West Transitway Tunnel

Pinecrest Road to the Southwest Transitway

Value Engineering Study

24 November 2009

STAGE 1	FIGURE 1A
TRANSIT VEHICLES IN THE 417 CORRIDOR - BOTH DIRECTIONS

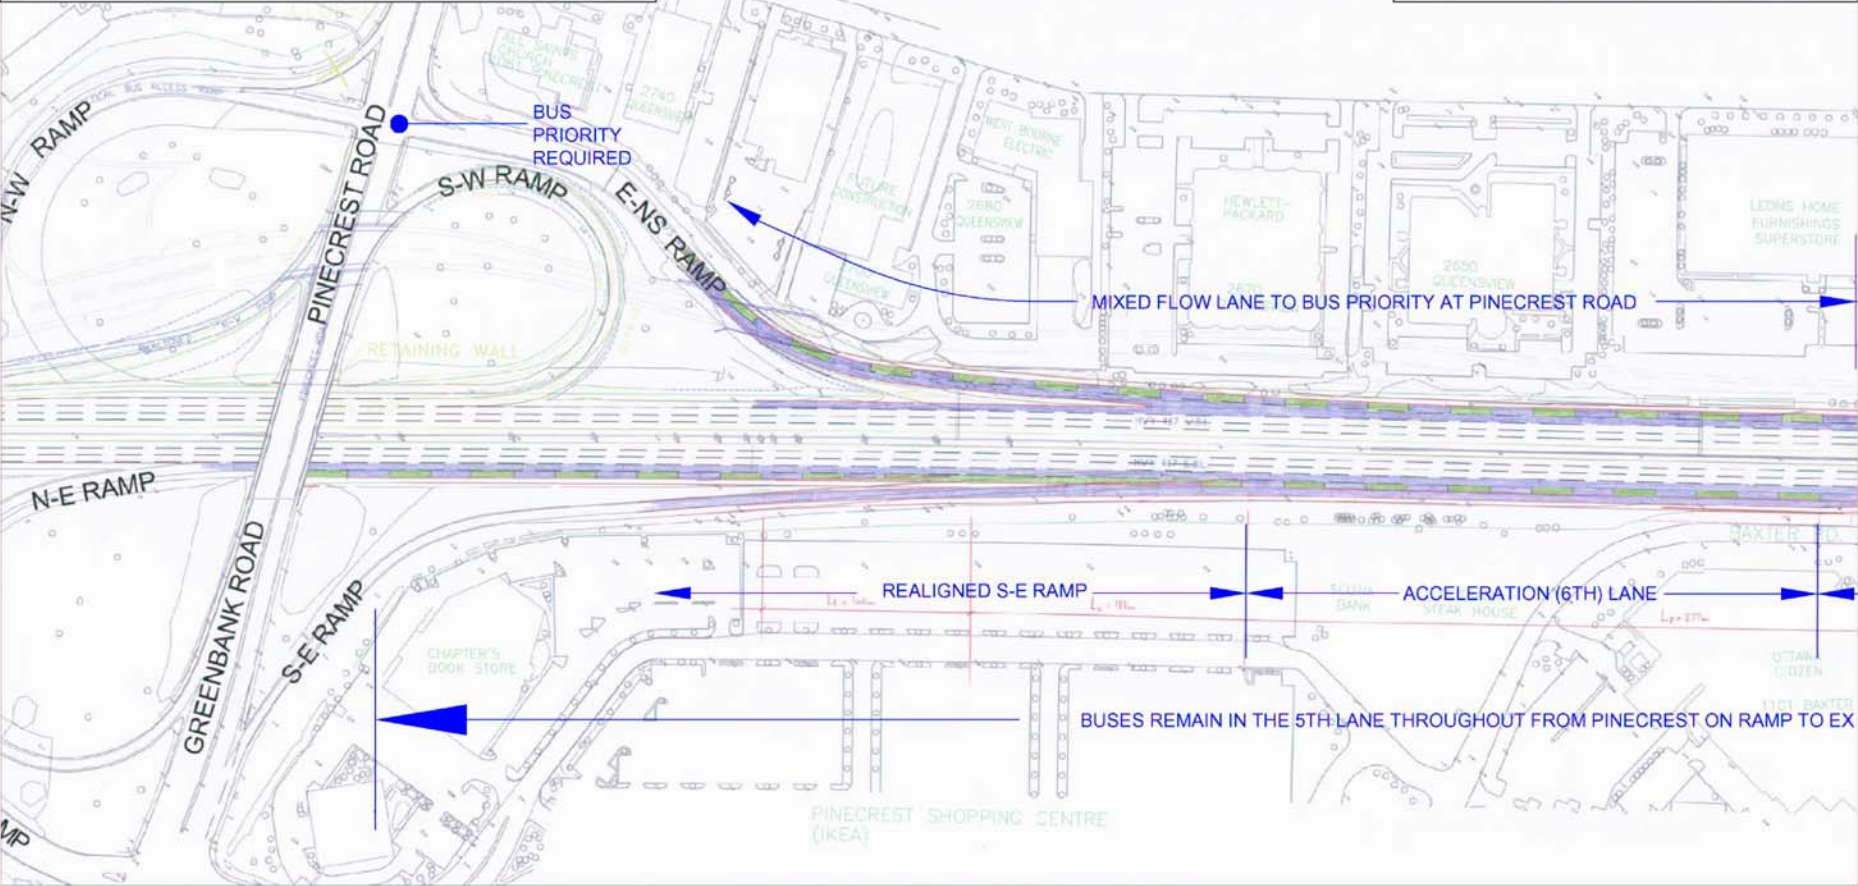
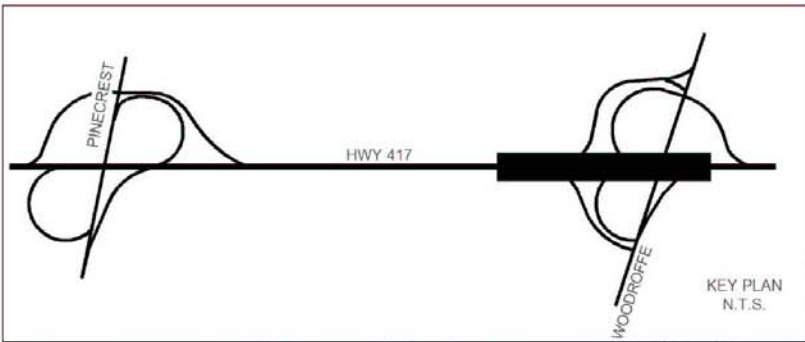
Westbound buses can avoid Pinecrest signals by staging grade separation

Westbound buses use exclusive bus lanes (consistent travel speeds)

Eastbound buses have several sub-alternatives including innovative alternative with ramp crossing bus lane

ST-32: Review Queensway Corridor as Long Term Alternative

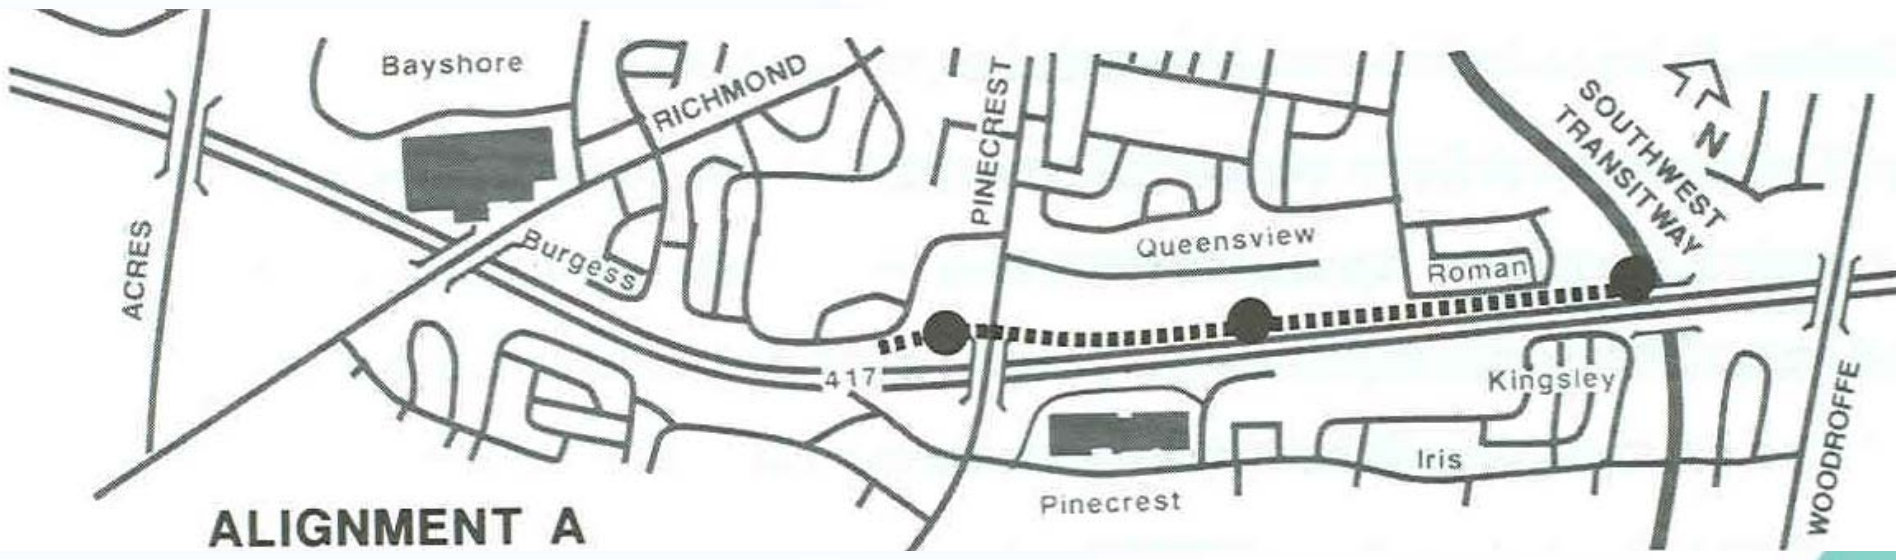
- **Description**
 - **Construct transitway adjacent to 417 on north side by removing houses on south side of Roman Avenue to eliminate tunnel and park crossing (Alternative A)**
- **Advantages**
 - **Tunnel not required**
 - **Minimal service disruption during construction**
 - **Minimal increase in noise**
 - **Provides direct access to Pinecrest garage**
 - **May be convertible to LRT**
- **Disadvantages**
 - **Removal of 25 homes on Roman Avenue**
 - **Increases exhaust and noise in MTO corridor**
 - **New structure required at Queensway station**
- **Cost implications**
 - **Approximately \$30 million Cost Savings**
